# 21150 PCI-to-PCI Bridge

Specification Update

*October 2001*

Order Number: [278258-009](#)

Figure 1. S\_Clock Multiplexer Workaround Circuit for Errata 6.

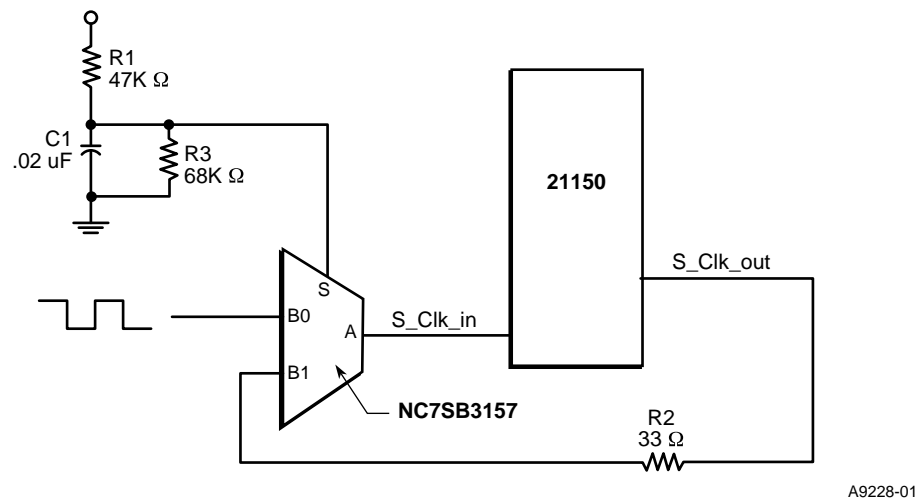
**Workaround:** Three alternative workarounds are provided for this errata:

1. [Figure 1](#) illustrates the first recommendation - a circuit where an on-board pulse source is gated via the B0 input of the multiplexer to the `S_Clock_in` pin of the 21150.

At time 0, the S input of the multiplexer is low, allowing pulses from the on-board pulse source, connected to the B0 input, to be provided to the 21150 `S_Clk` input pin. When the time determined by the R/C network is satisfied, the S input pin will be in a logic High state. The Multiplexer will then shut off the input pulse from S0 and will direct the `S_Clock_out` pulses via the B1 multiplexer input, into `S_Clock_in`.

The values used for the R/C network should be selected to allow a minimum of 2 pulses to be delivered to the 21150 after V<sub>dd</sub> has reached 3.0V at a frequency not to exceed the appropriate PCI component. i.e. 30 ns for a 33Mhz bridge. These values should be chosen based on the rise time of the power supply and the frequency of the on board pulse source. The values given for R1, R3, and C1 are for example purposes only.

**Note:** The NC7SB3157 2:1 Multiplexer / Demultiplexer Bus Switch used in this example has a maximum propagation delay of 800ps that should be taken into consideration when matching trace lengths of the clock lines to avoid introducing excessive skew in the clocks. All S\_Clock etch lengths must be matched to within 2ns @ 33Mhz or 1ns @ 66Mhz. The addition of this circuit requires that the etch length for the S\_clock\_in signal be reduced to compensate for the 800ps delay.

Figure 2. Recommended Circuit for a Tristable Buffer

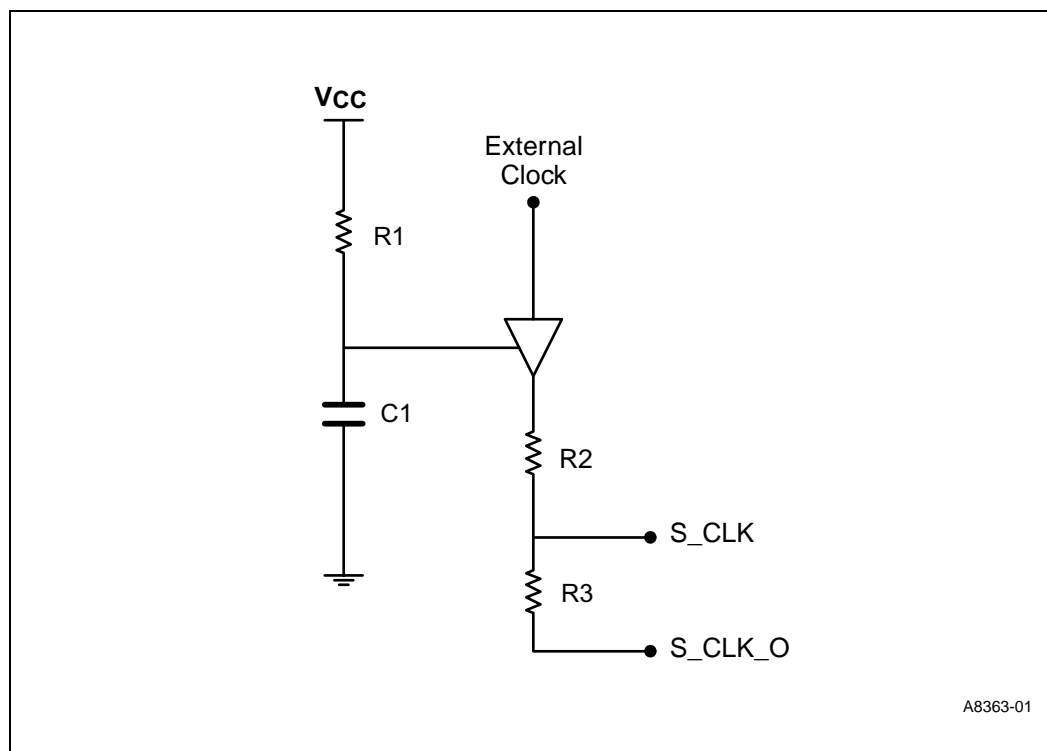
3. In the third recommendation, to guarantee the proper initialization of the s\_clk circuits the addition of an external circuit that would provide a minimum of two transitions on the s\_clk input during the power-up ramp is necessary. This can be done using a solution that drives an external clock onto the s\_clk input while 3.3V V<sub>cc</sub> is ramping during power up.

Figure 2 illustrates the use of a tristable buffer to provide multiple pulses to the s\_clk input. The V<sub>cc</sub> ramp rate and R1,C1 time constant determine the duration and amplitude of the pulses generated during power up. The R2-R3 values are chosen based on applicable board etch impedance-matching requirements.

The following should be considered in calculating the R1,C1 time constant

- Make the time constant of the circuit as short as possible, while still ensuring that a minimum of two pulses are generated during the Vcc ramp.
- Phase delay between **s\_clk\_o** and the external clock should be minimized.
- Matching the external clock and **s\_clk\_o** frequencies to reduce contention.
- Laboratory experiments using **p\_clk** as the external clock and a R1C1 time constant between 40 and 60 percent of the Vcc ramp have been successful using this configuration. However the use of **p\_clk** as the external clock violates the PCI bus specification for loading of the primary clock.

**Figure 20. Clock Mask and Load Shift Timing**

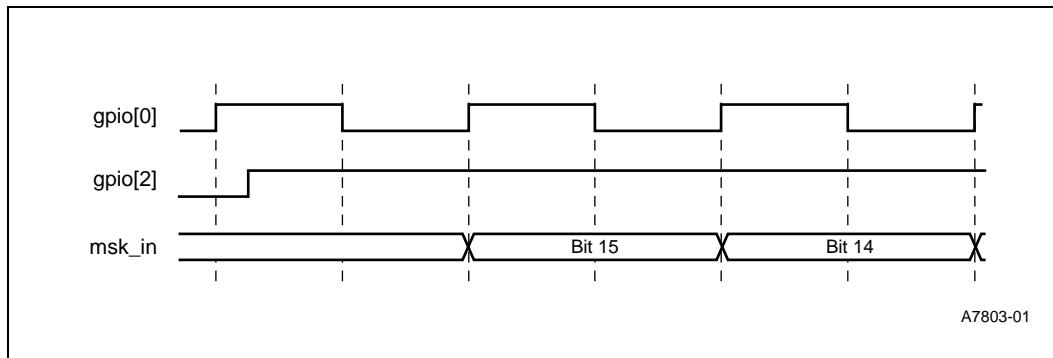
2. **Section 10.2, Secondary Clock Control, Figure 20**

This figure now appears as follows:

**Figure 4. Signal trst\_l States**

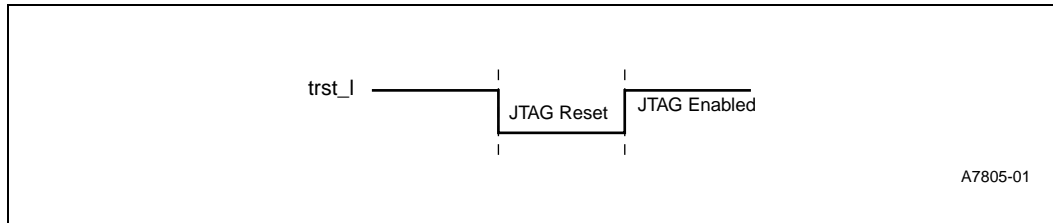
**6. Section 5.1, Initialization, Description**

This section has been changed to:

The test access port controller and the instruction register output latches are initialized and JTAG is disabled while the trst\_l input is asserted low (see [Figure 4](#)). While signal trst\_l is low, the test access port controller enters the test-logic reset state. This results in the instruction register being reset which holds the bypass register instruction. During test-logic reset state, all JTAG test logic is disabled, and the device performs normal functions. The test access port controller leaves this state only after trst\_l (low) goes high and an appropriate JTAG test operation sequence is sent on the tms and tck pins.

During normal 21150 operation the JTAG logic must be disabled by pulling trst\_l low using a 5K resistor.

Figure 26. 21150 256 PBGA Mechanical Drawing

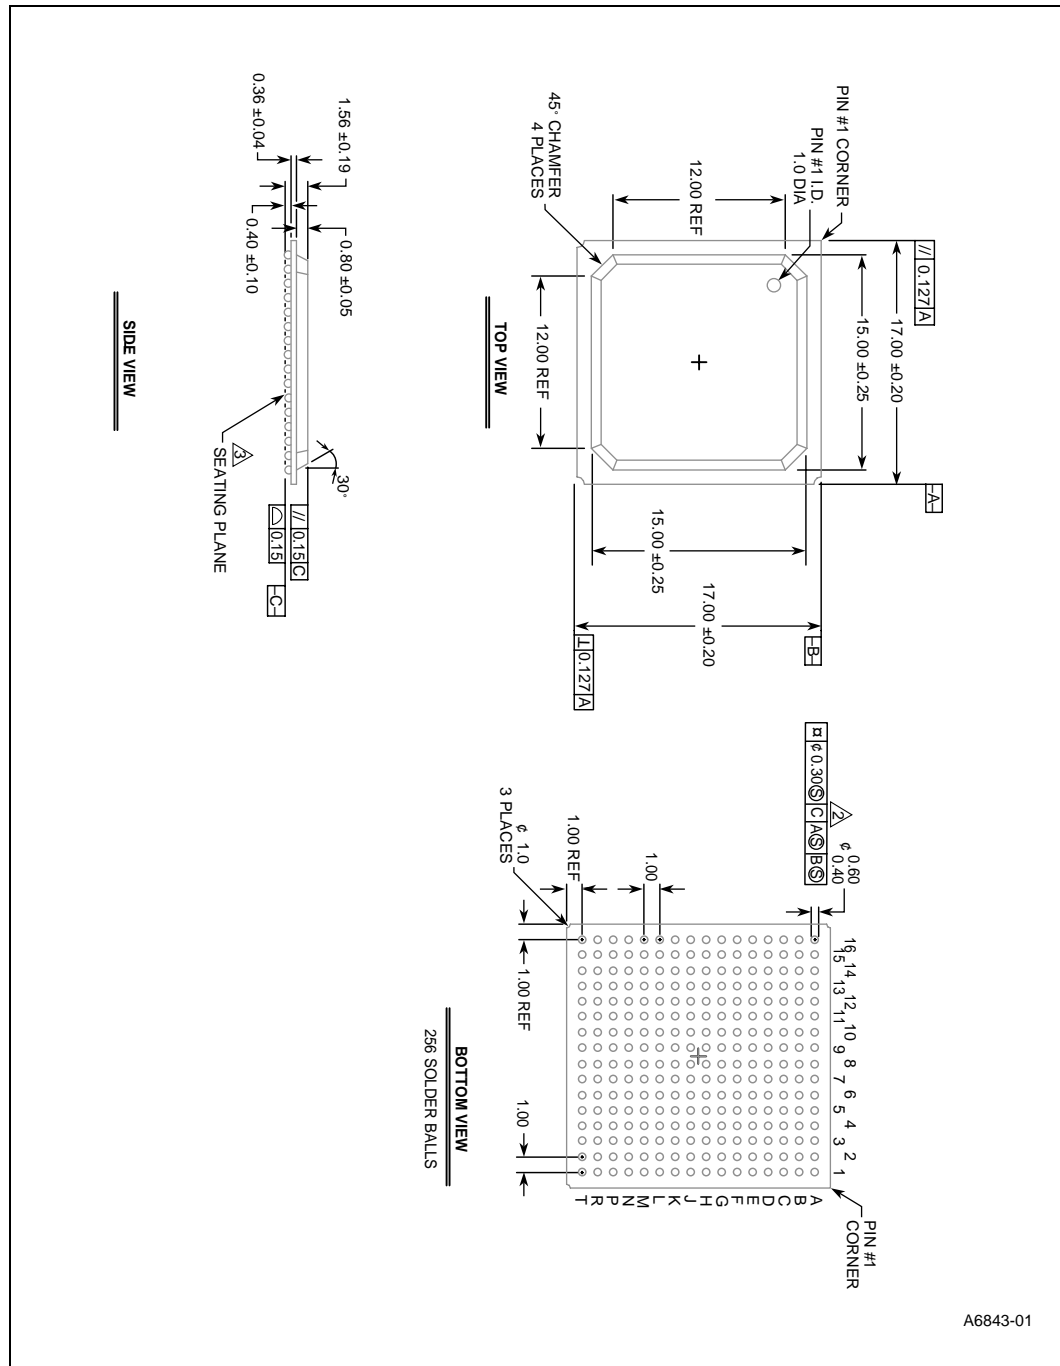
**9. Mechanical Specifications: Section 18**

Figure 26 and Table 51 have been added to show that the 21150 also supports the 256 pin plastic ball grid array.

**Figure 2. Removal of pull-down resistor for JTAG testing**

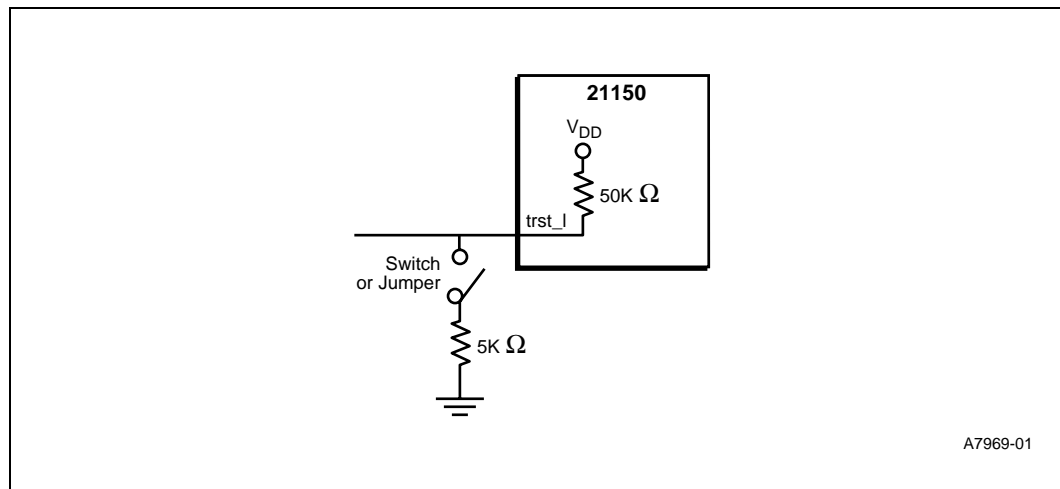
**10. Section 6.3.1, Signal trst\_l Pull-down Resistor, new section**

The following new section has been added:

A 5 K  $\Omega$  pull-down resistor is required on trst\_l for normal PCI-to-PCI bridge operation. However, some JTAG test results may be inconclusive if the 5 K  $\Omega$  resistor remains in the circuit. To obtain accurate JTAG results, Intel recommends one of the following solutions:

- Verify that the JTAG test equipment, after driving trst\_l low to reset the TAP controller, constantly drives trst\_l high during JTAG tests. If this signal is not constantly driven high, the 5 K  $\Omega$  resistor will pull the signal to a low state.
- Remove the 5 K  $\Omega$  resistor during JTAG tests. This resistor must be installed during normal PCI-to-PCI bridge operation.
- Design external circuits with a switch or jumper to isolate the 5 K  $\Omega$  resistor during JTAG tests (see [Figure 2](#)). This switch must enable the resistor during normal PCI-to-PCI bridge operation.

**Figure 19. Example of gpio Clock Mask Implementation on the System Board**

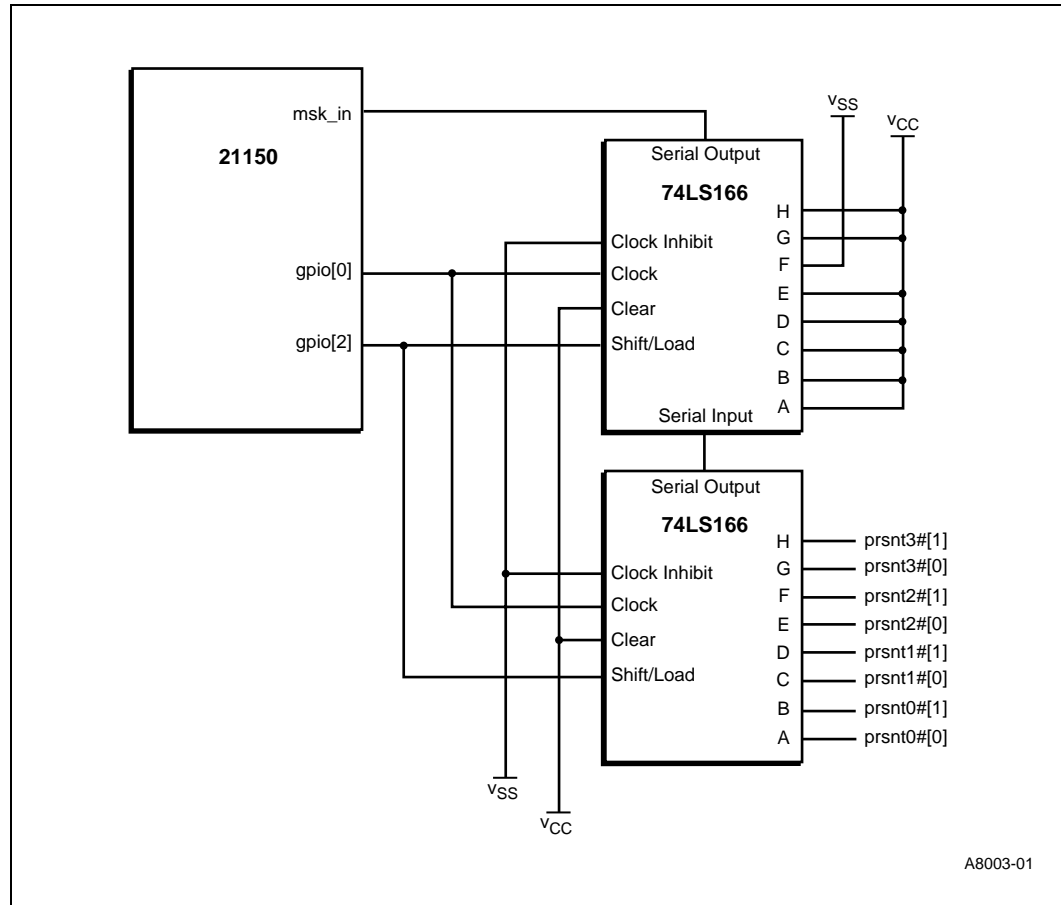
**12. Section 10.2, Secondary Clock Control, Figure 19**

This figure now appears as follows:
